GWS Septic System Design Review

RE: Request for an Improvement Permit for Lot 14 off of Sample Road.
MCHD File #6752B

SEPTIC SYSTEM DESIGN REVIEW WORKSHEET

Address: Lot #14 Sample Rd.

Scale: 1 inch equals 50 feet	S&ME	Faison-Sample Road, LLC	FIGURE
Drawn by: JBP		Lot 14	1
Reviewed by: Jeremy P. Michelone, RS		Mecklenburg County, NC	
Date: March, 2007	ENVIRONMENTAL SERVICES · ENGINEERING · TESTING	S&ME Project #1588-05-091

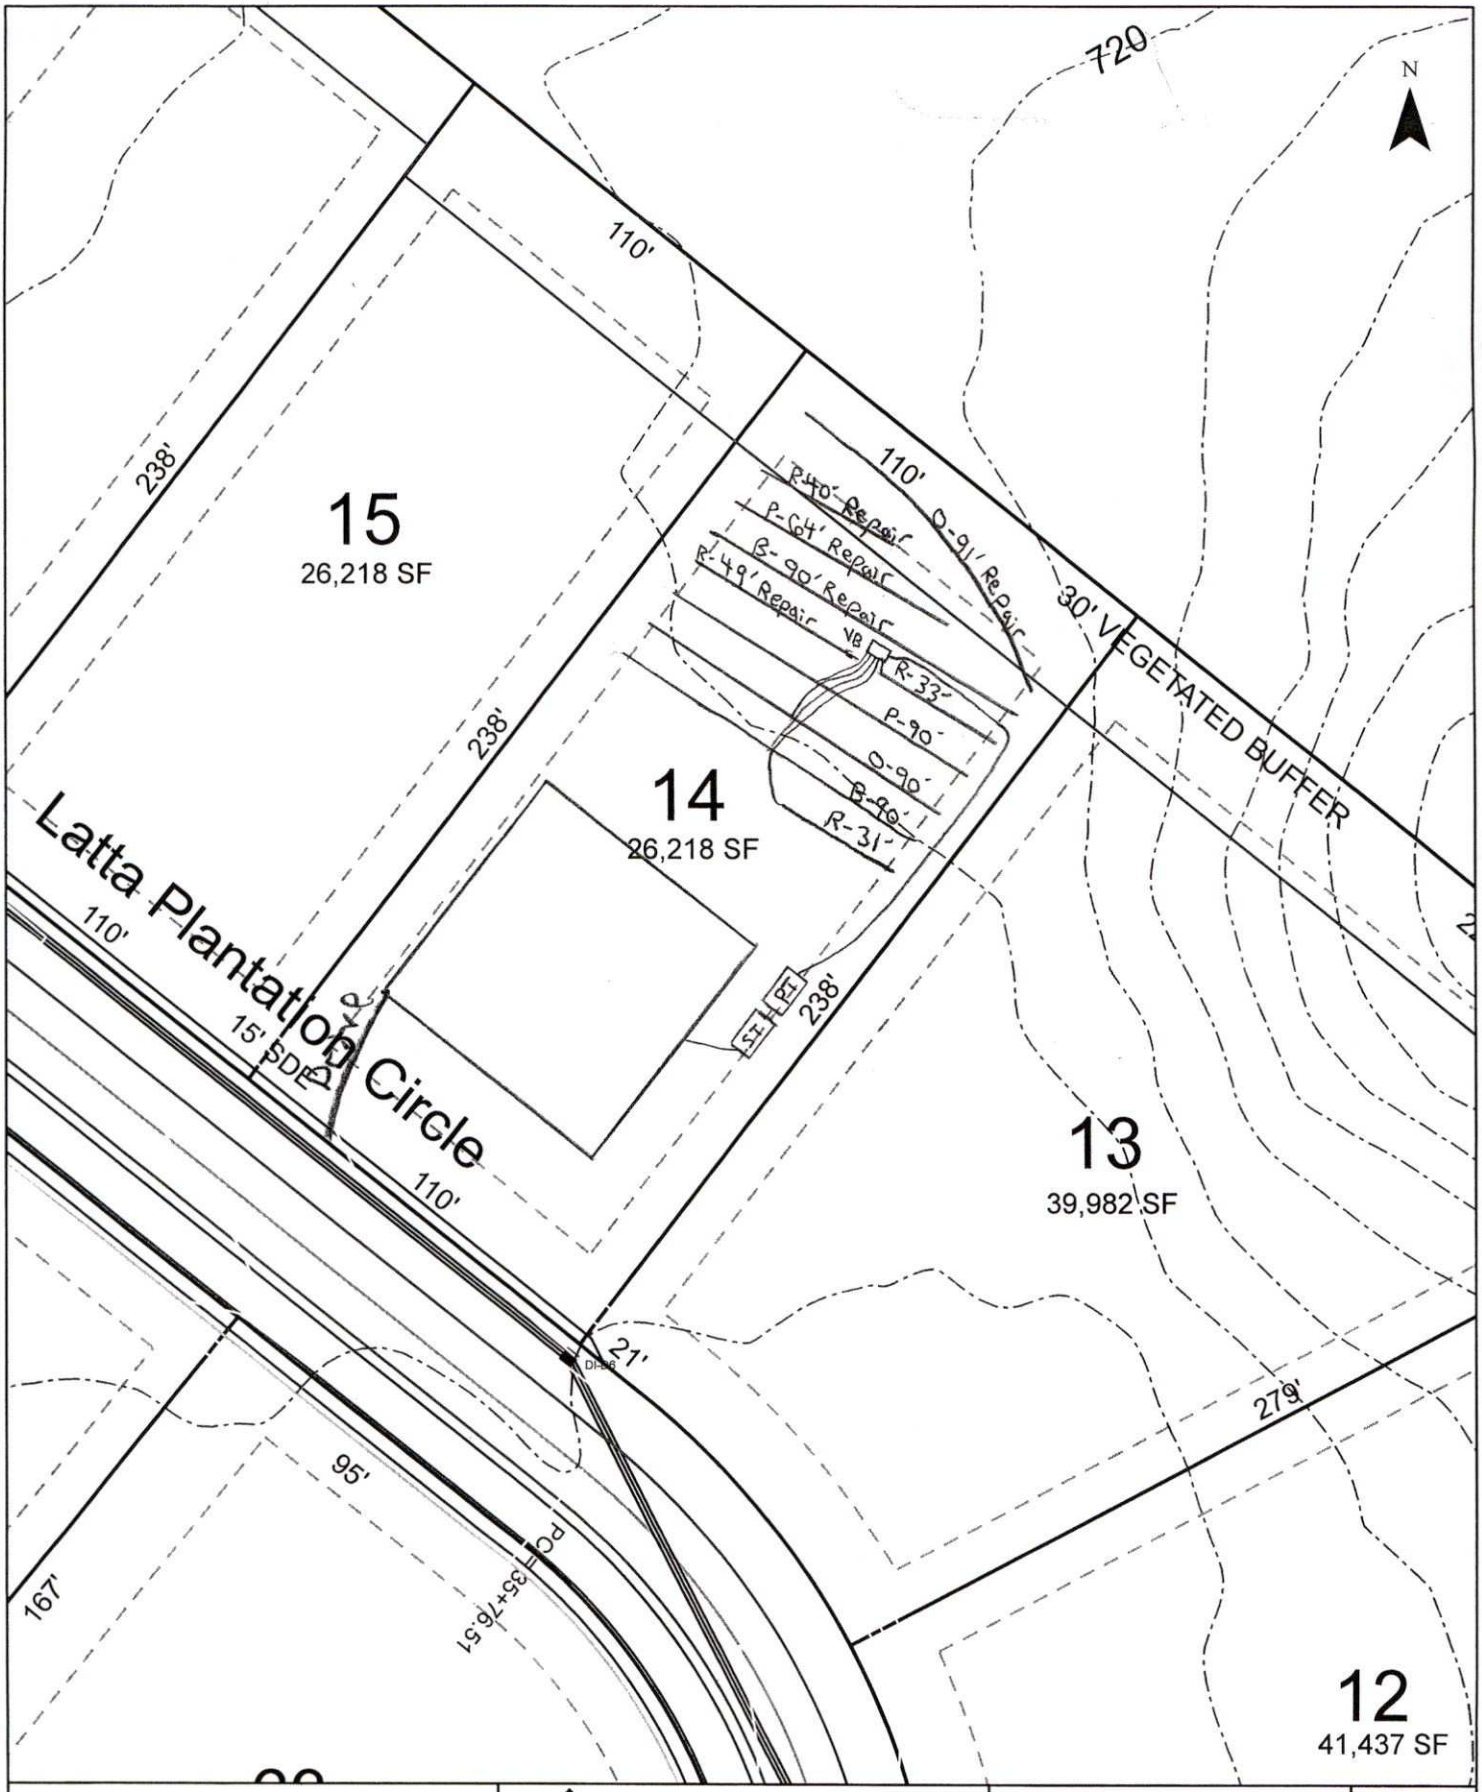
1. Soil report and application needs to be updated to show review for 5 bedroom house (600 GPD).
2. Dosing Volume calculation needs to be 266 gal. Spec sheet shows it at 295 gal.
